APPLEGATE DRAYAGE P98-006

- REQUEST:
- A. Negative Declaration,
 - B. Mitigation Monitoring Plan,
 - C. "R" Site Plan Review for the development of a 21,650 sq. ft. (14,250 square foot warehouse, 5000 square foot office, 2400 Square foot. maintenance shop) warehouse/distribution facility.

LOCATION: Northwest corner of the intersection of Raley Blvd. and Vinci Ave
APN: 215-0230-042.
North Sacramento (Grant Joint Union School District)
Council District 2

Exhibit C-2 Site Plan

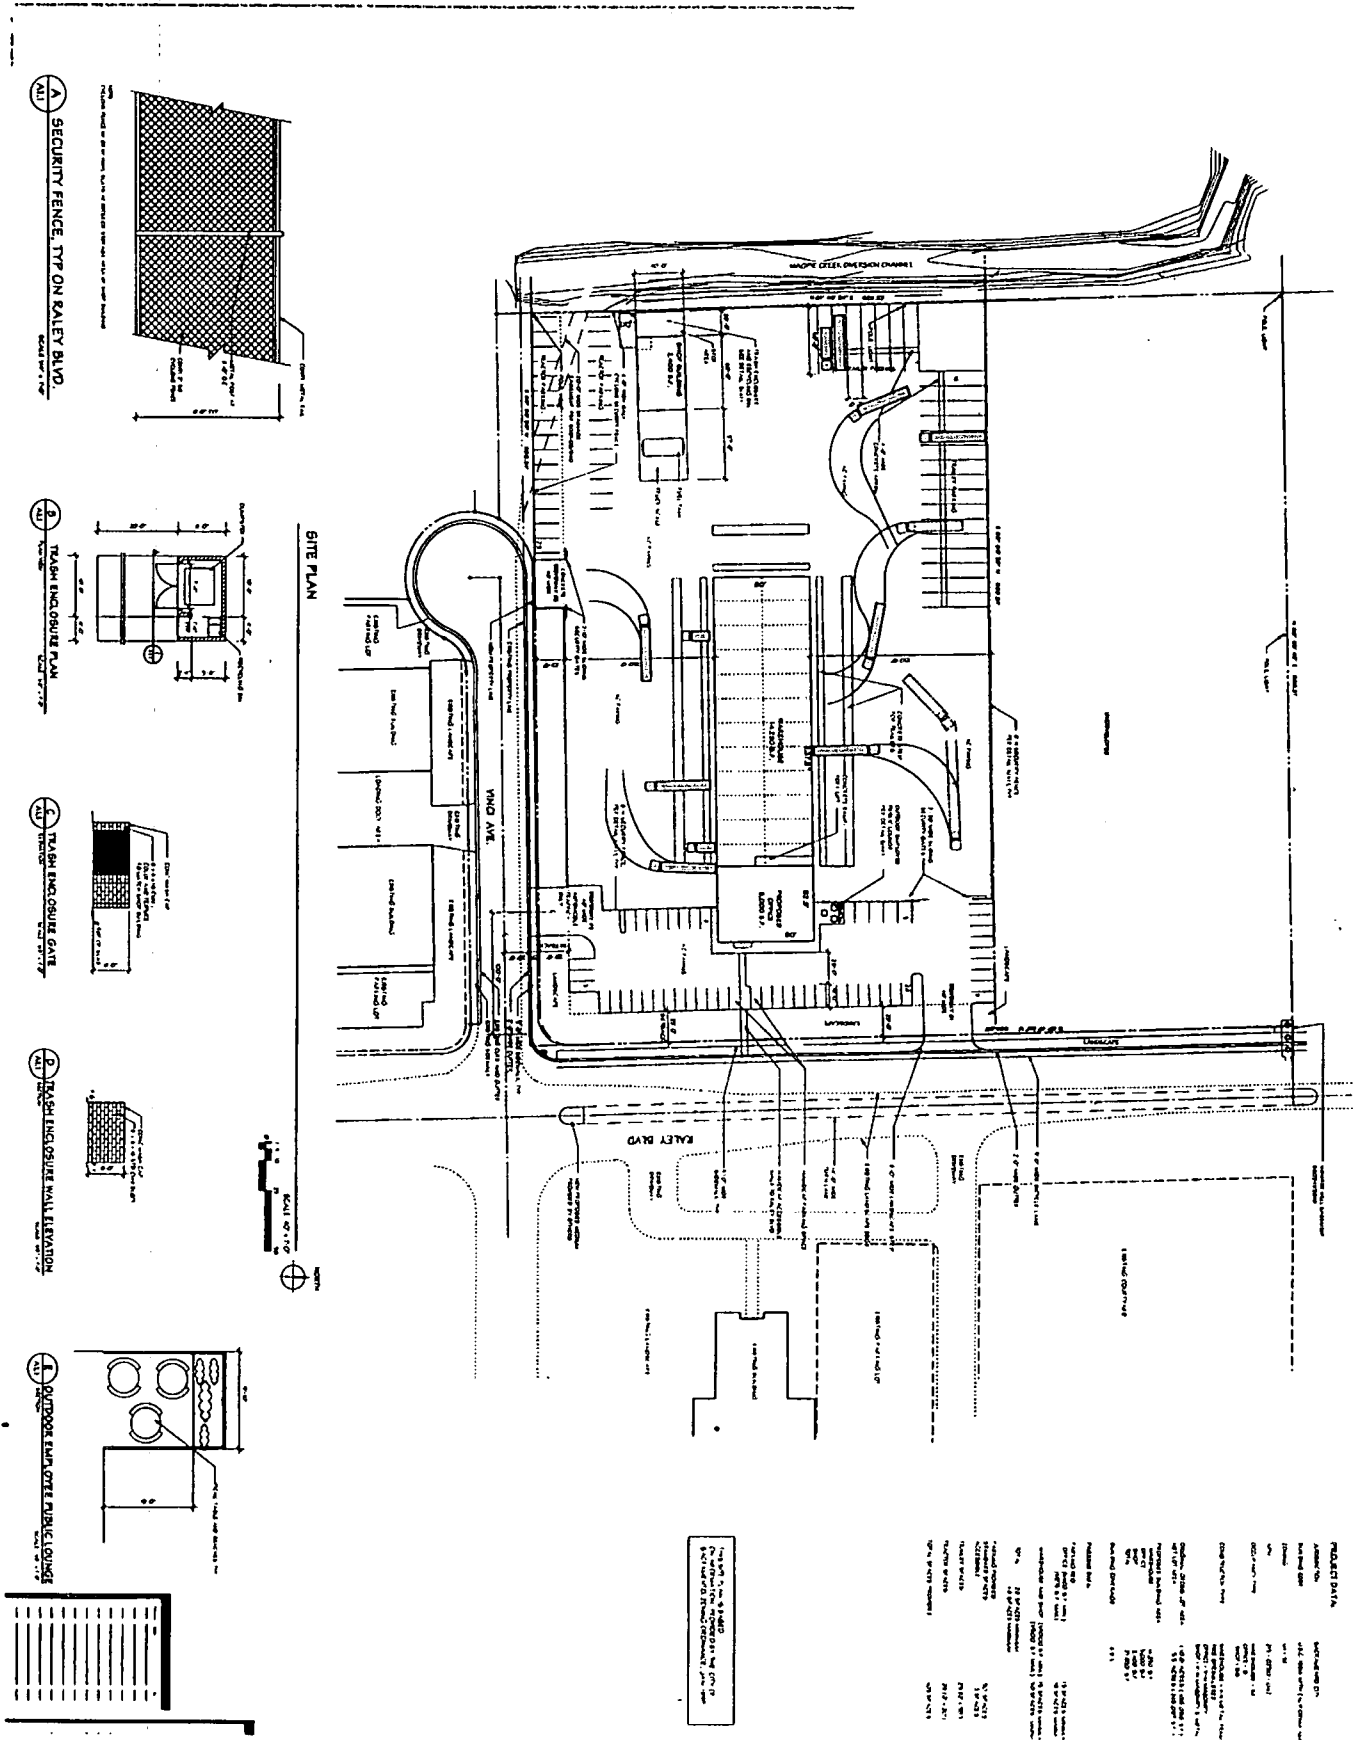
- C24. As noted on the site plan, a 20' wide drainage easement exists across the southwest corner of the property. A copy of the easement shall be provided to the Department of Utilities prior to plan approval.

- C25. If Vinci Ave. is extended to the west, across Magpie Creek, the project site shall conform to the 25' foot landscaping criteria of the M-1S-R zone along the entire south boundary.

- C26. The fence along Raley Blvd. shall be vinyl clad, as well a 12' return from Raley on the north side. The fence along Vinci Ave. shall be vinyl clad to the east edge of the truck entry drive.
